ORIGINATION FORM

Proposed Revisions to a Standard Plans Index (Please provide all information — Incomplete forms will be returned)

Index Number: 450-511

Index Title: Bearing Plates (Type 1) -Prestressed Florida-I and
AASHTO Type II Beams**Summary of the changes:**

LAST REVISION 07/01/14	REVISION	DESCRIPTION:		FY 2020-21 STANDARD PLANS	BEARING PLATES (TYPE 1) - PRESTRESSED FLORIDA-I AND AASHTO TYPE II BEAMS	INDEX 450-511	SHEET 2 of 2
---------------------------	----------	--------------	--	------------------------------	---	------------------	-----------------

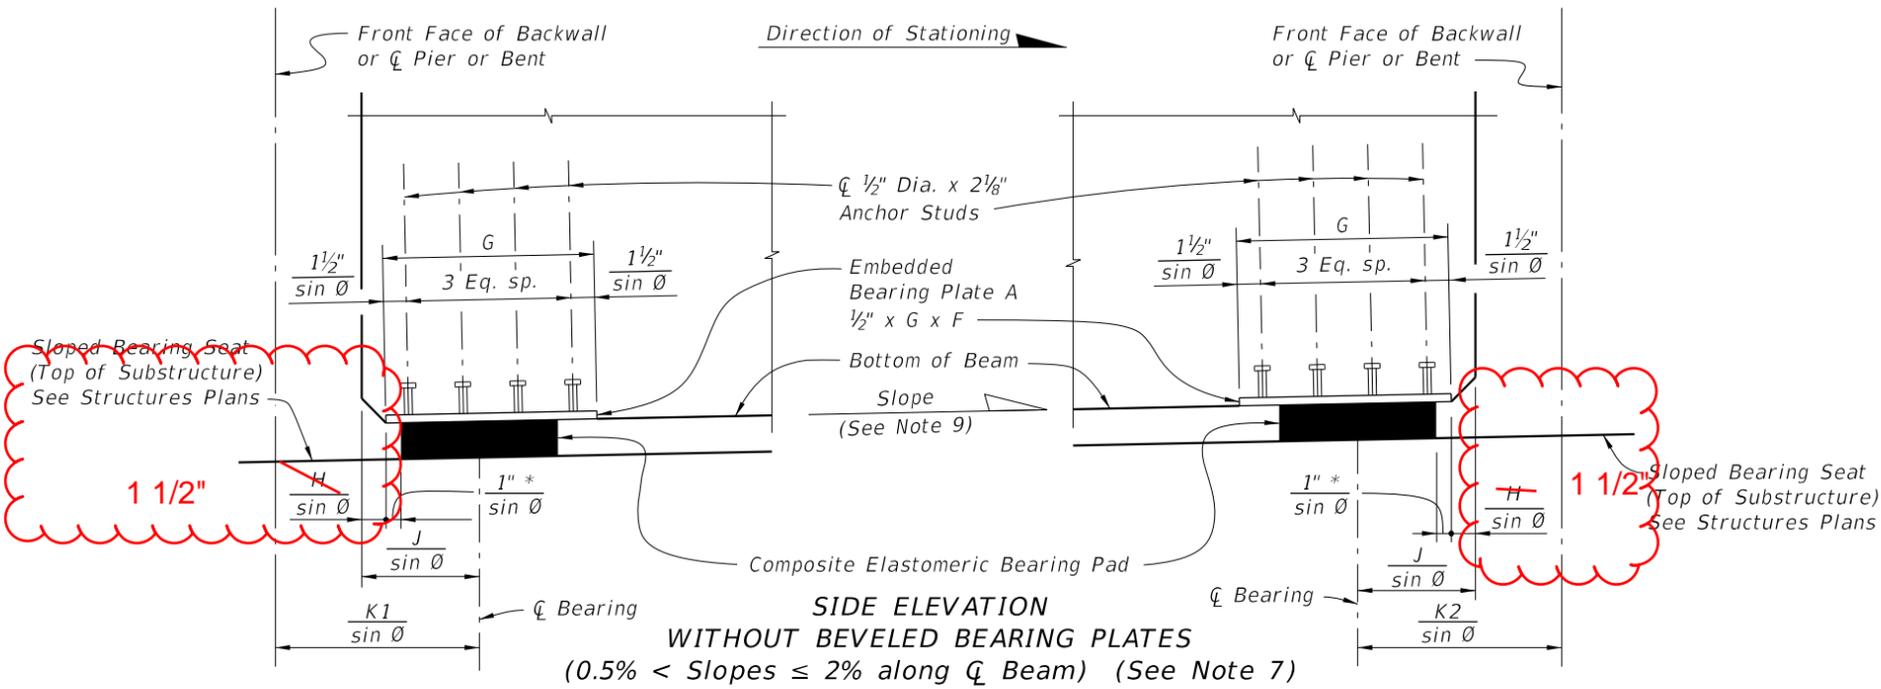
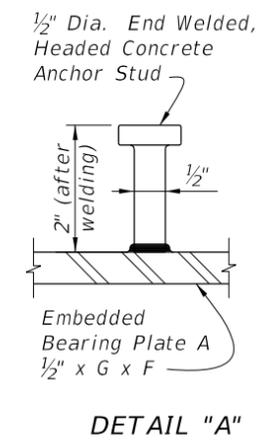
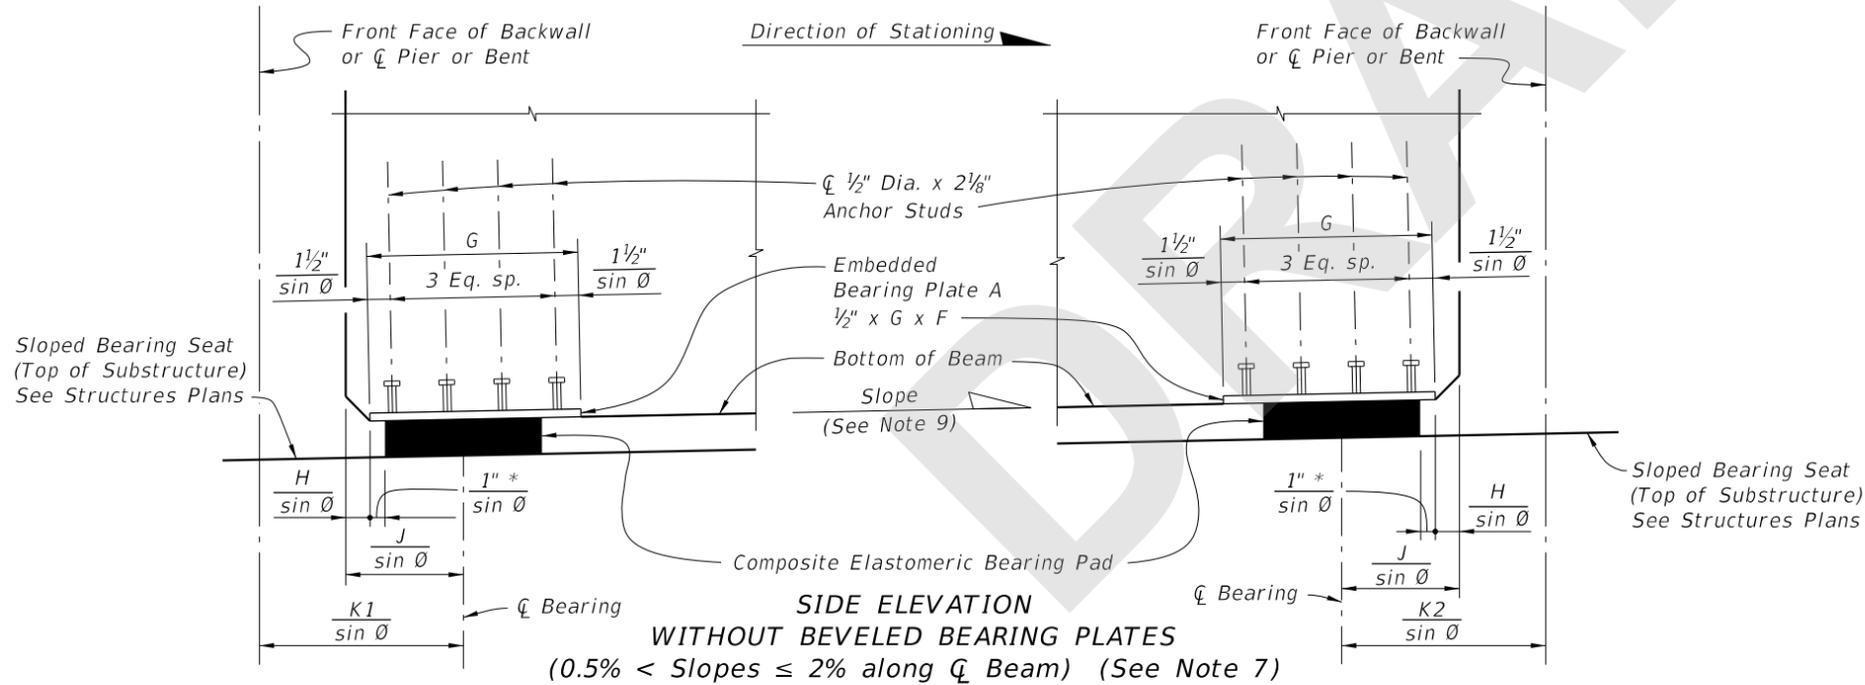
Delete dimension H (replace with number).

CROSS REFERENCE:
See Sheet 1 for ~~dimension H~~ and Notes.

H as shown is a hard dimension that does not change; therefore change it to 1 1/2".
